COUNTY OF BERKS

NOTICE TO BIDDERS

Amendment #2 Issued on May 8, 2023

Re: Invitation to Bid #23-12-GR

Schedule of Drawings – Amendment #2 – Sheet A-101 – Slab Repair Plan

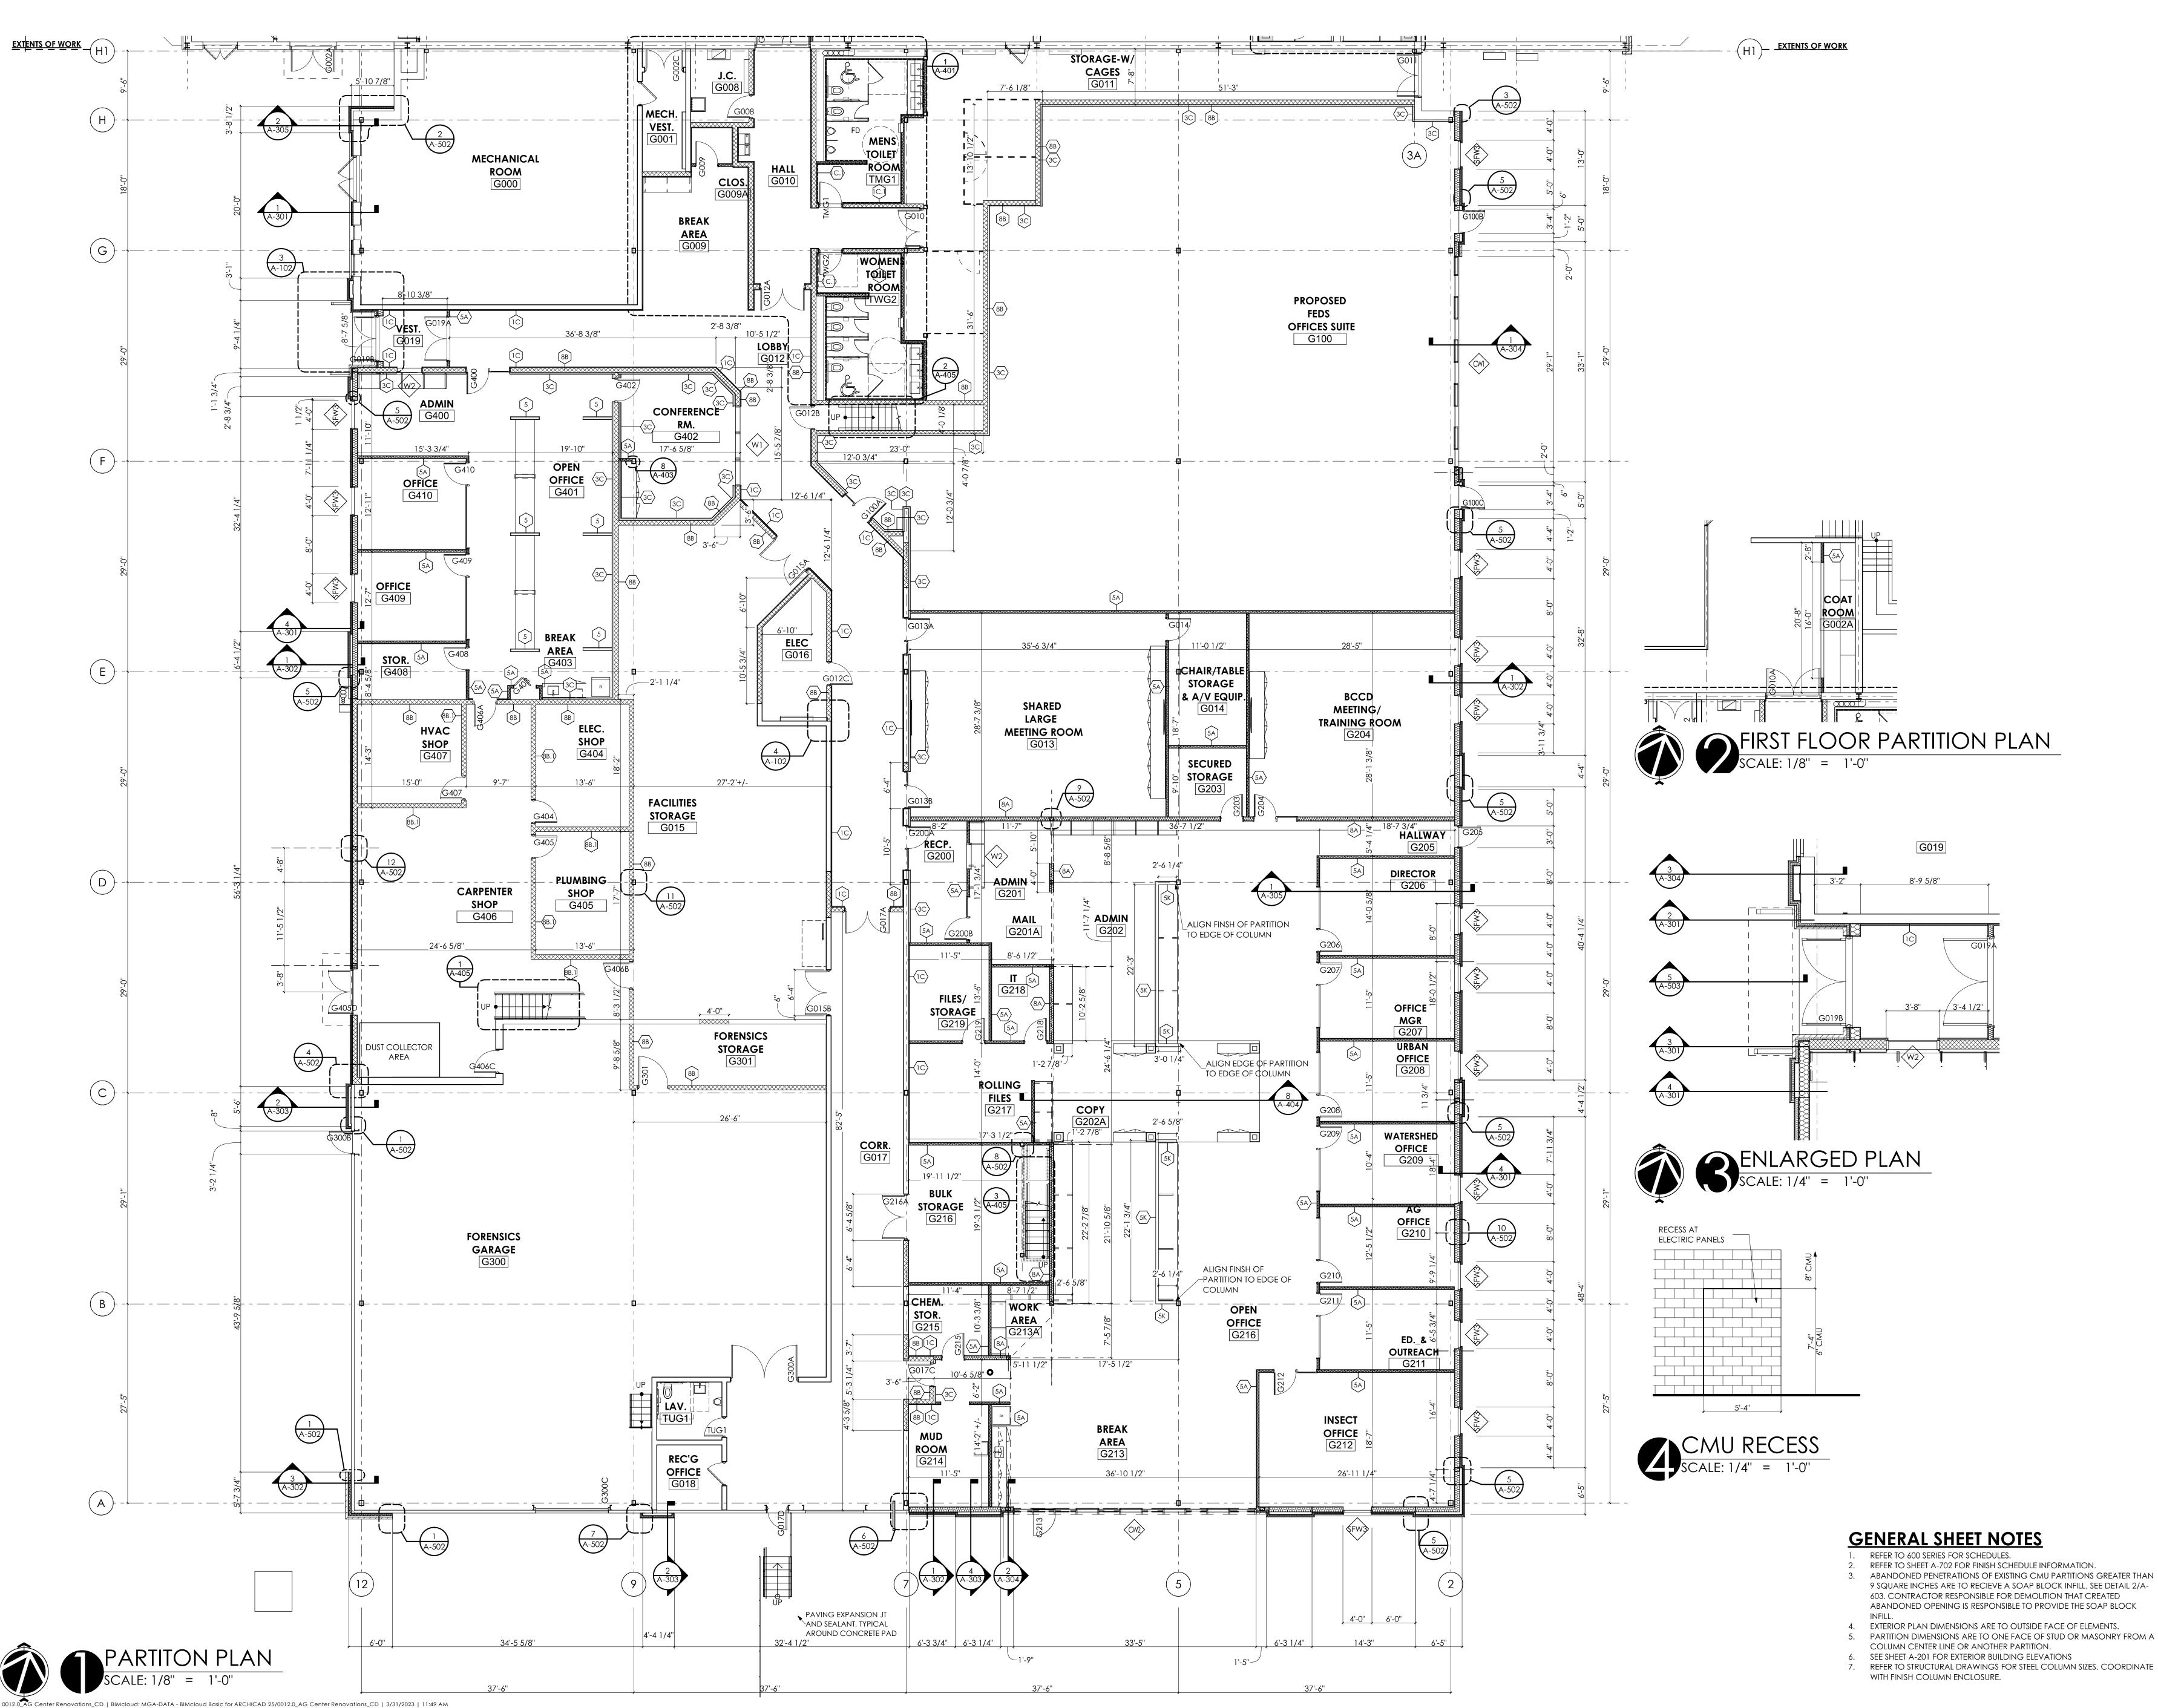
- Sheet A-101 Slab Repair Plan: Additional slab cuts are indicated via clouds on the attached revised drawing.
- Sheet A-601 Schedules: Revised to clarify the storefronts listed in Drawings 5 as "Storefront Systems" and the storefronts listed in Drawing 10 as "Interior Storefront Systems". In addition, the frame on Door No. G212 shall be type F3 and the frame on Door No. G300B shall be type F1.
- Sheet H-100 First Floor HVAC Plan: Increase the quantity of plastic pipe plus fittings from fifty feet (50') to two hundred feet (200').
- Sheet H-100D HVAC Demo Plan: Delete demolition notes for Lav TUG1 and Rec'g Office G018.

- Q19: Can you clarify the cutting, patching, and excavation work responsibilities for each contractor?
- A19: Sheet A-101, Slab Repair Plan, on Schedule of Drawings Amendment #2, notes each prime that requires the slab to be cut is to provide the location and layout of slab removal. The General Contractor is to cut the slab and excavate to the depth required, coordinate with the other primes and Mechanical, Electrical, and Plumbing drawings. Each prime is to complete their own backfill to the stone base, the General Contractor is to provide the stone base and concrete patch.

CONCRETE, COORDINATE WITH STRUCTURAL DRAWINGS. 3.30.20 LOCATION OF SLAB REMOVAL OF PROPOSED SANITARY LINE. P.C. TO PROVIDE EXACT LOCATION. G.C. TO CUT SLAB AND EXCAVATE TO DEPTH REQUIRED BY P.C. P.C. PROVIDE BACKFILL. G.C. TO PROVIDE STONE BASE AND CONCRETE PATCH. COORDINATE WITH PLUMBING
